# MEETING AGENDA

## Planning and Zoning Commission

Village of Homewood

September 12, 2024

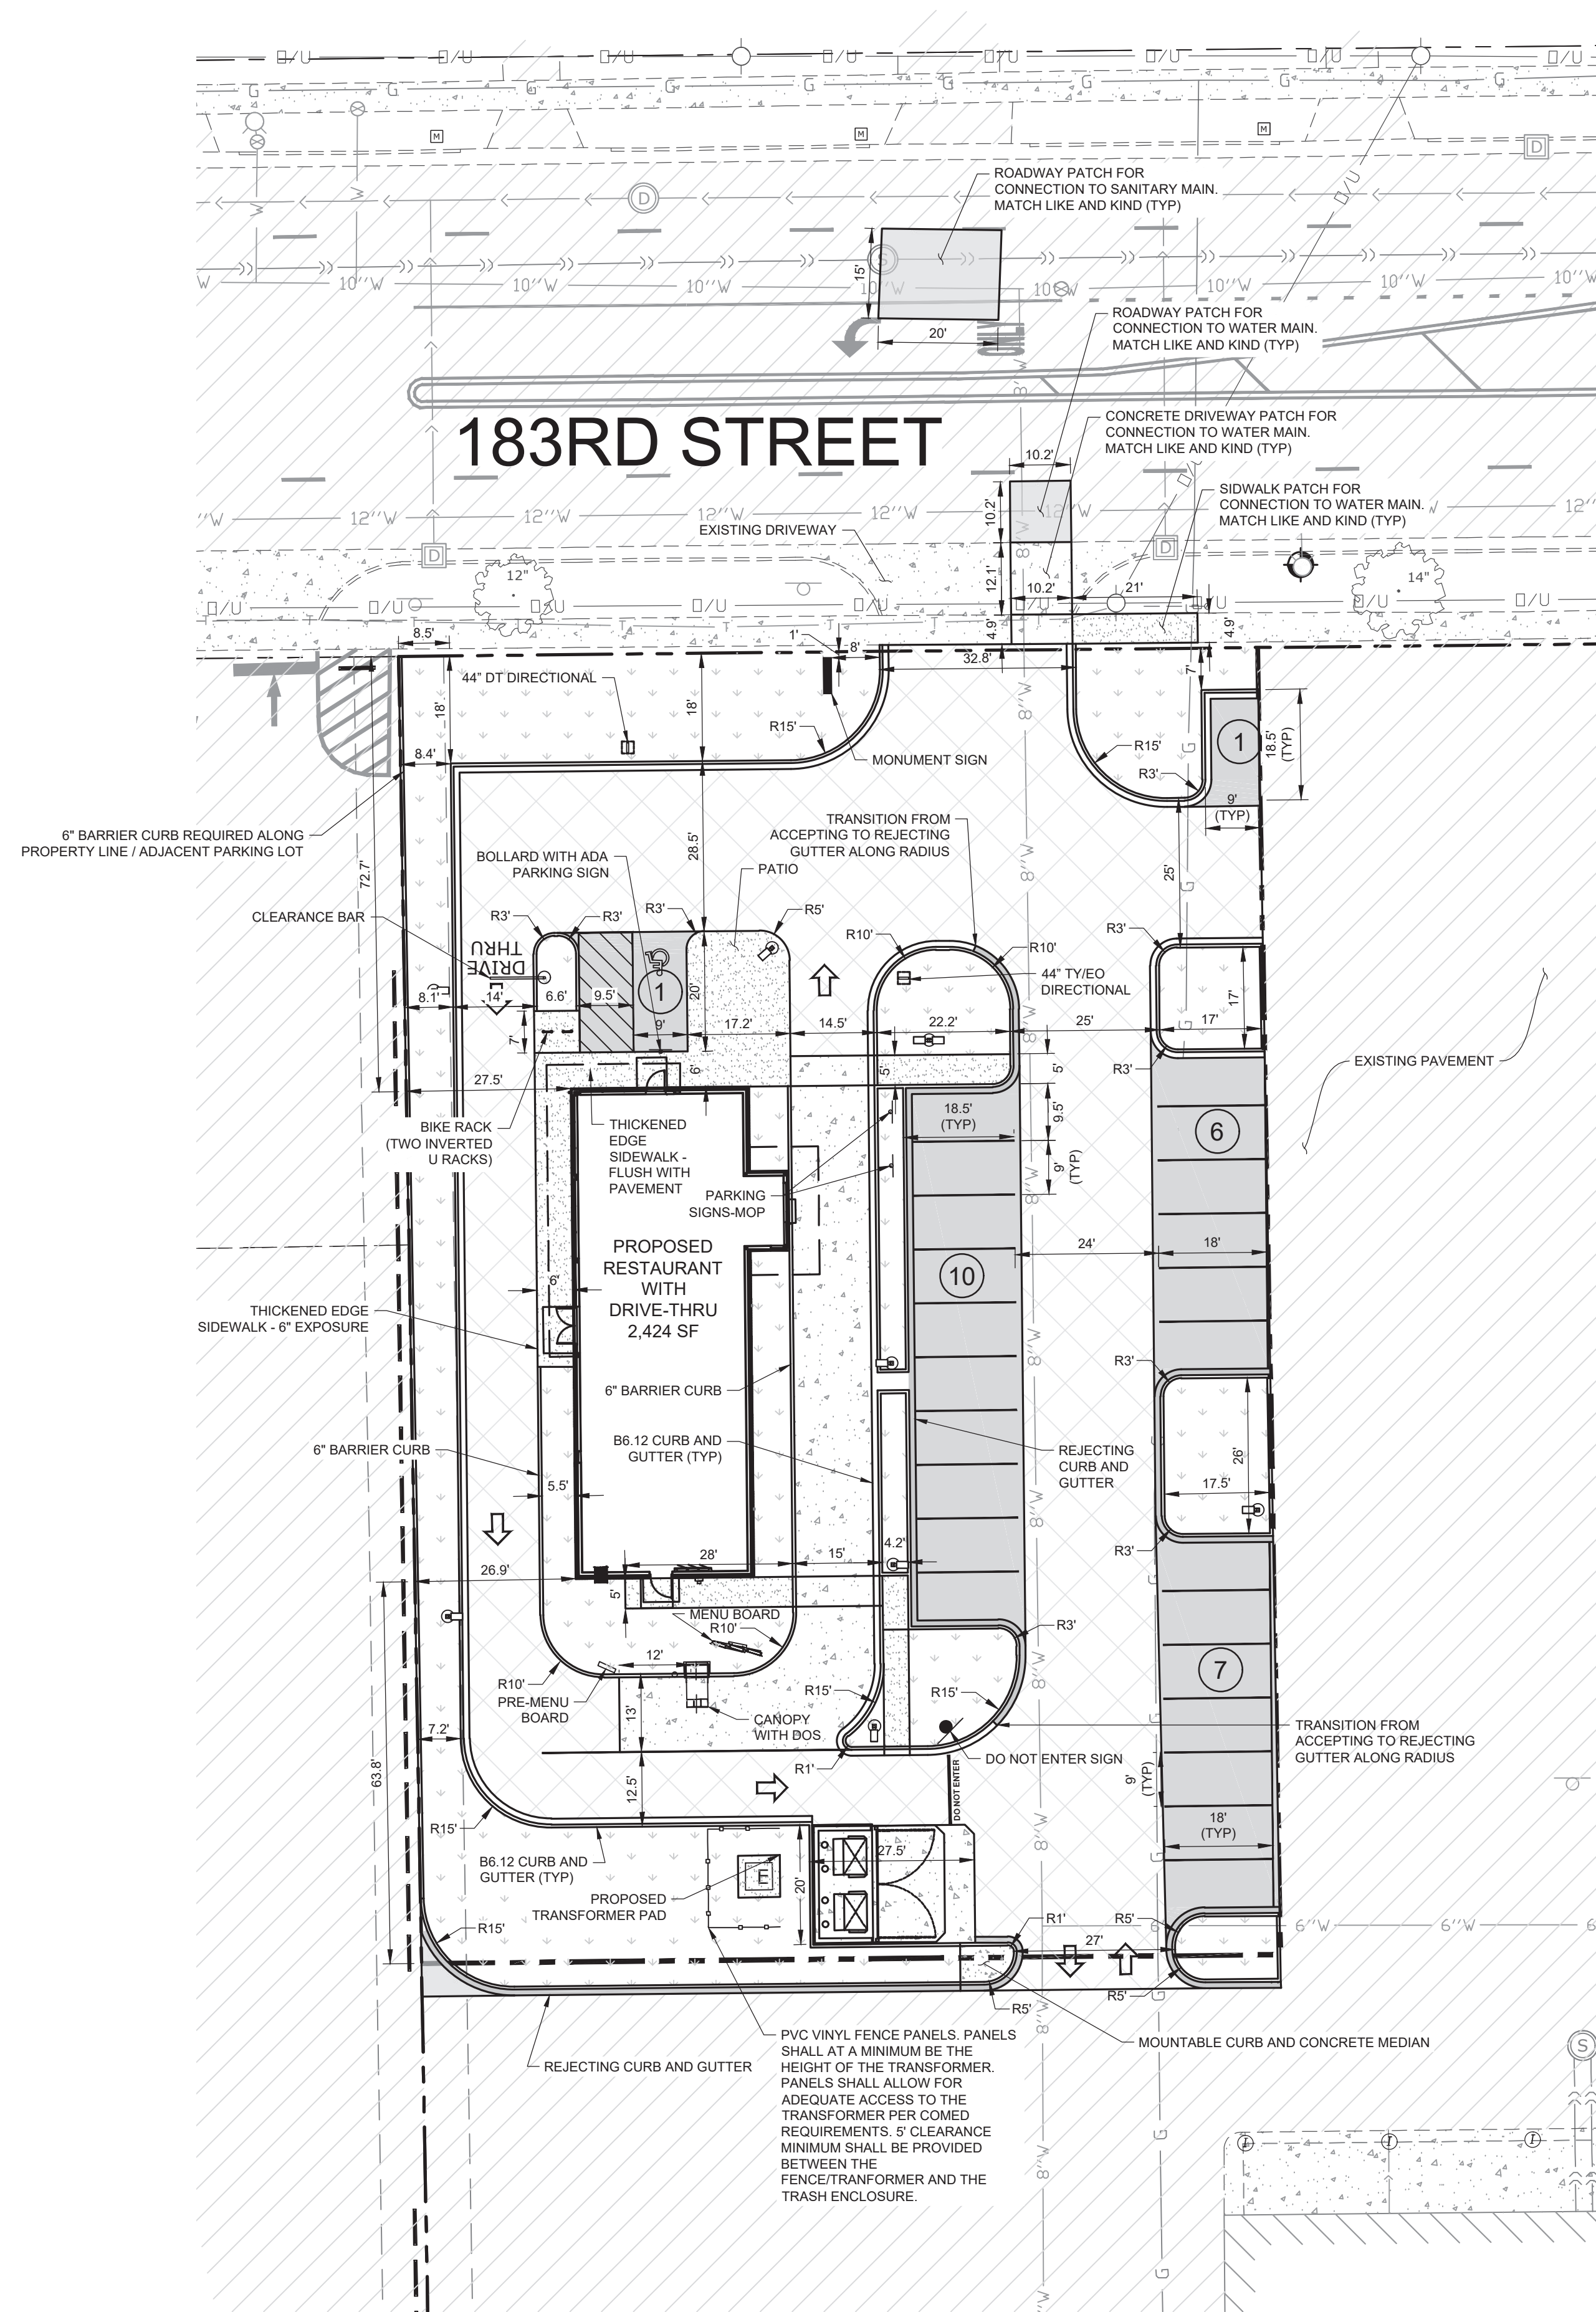
Noah Schumerth asked if they could shift the northeast corner parking spaces so they are not cut off on the site.

Noah Schumerth stated that the landscape plan appears to comply with the zoning ordinance and that Tier I materials are represented

Noah Schumerth stated that any ground or roof-mounted equipment must be screened.

Noah Schumerth stated that the monument size complies with the sign code.
